Rally and Shift Spinner™ Bike Rear Sprocket Finger Guard Replacement

Models: Rally Spinner™ and Shift Spinner™ Chain Drive Bikes

Mfg. Date: Units prior to April 07, 2016

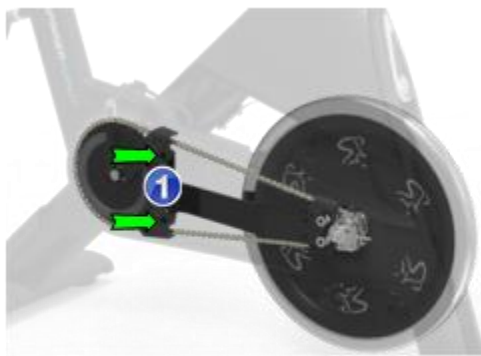
The chain finger guard length does not provide enough clearance for chain up/down travel. While riding you will hear scraping or clanging noises coming from the rear sprocket chain/belt guard cover.

Replace current finger guard with a new extended length finger guard.

QTY	Part Number	Description
1	PPP00FT39063452000	REAR FINGERGUARD, ADDITIONAL CLEARANCE

Chain Drive Spin Bike

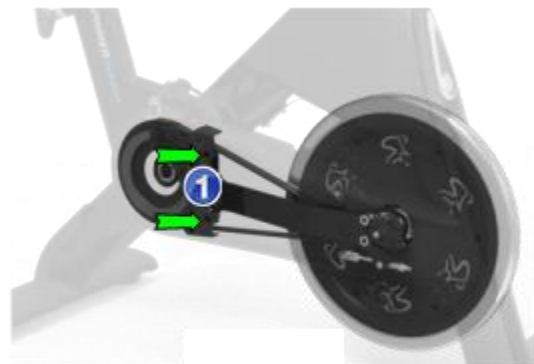
- 1 Remove the front and rear belt/chain guard covers.
- 2 Remove the rear sprocket finger guard **1** by removing the two fasteners using a 5 mm hex key. Keep fasteners for installation. Discard the finger guard.

- 3 Reinstall the new finger guard **1**, secure with two fasteners.
- 4 Replace belt/chain covers in reverse order.
- 5 Verify bike operation and return to service.
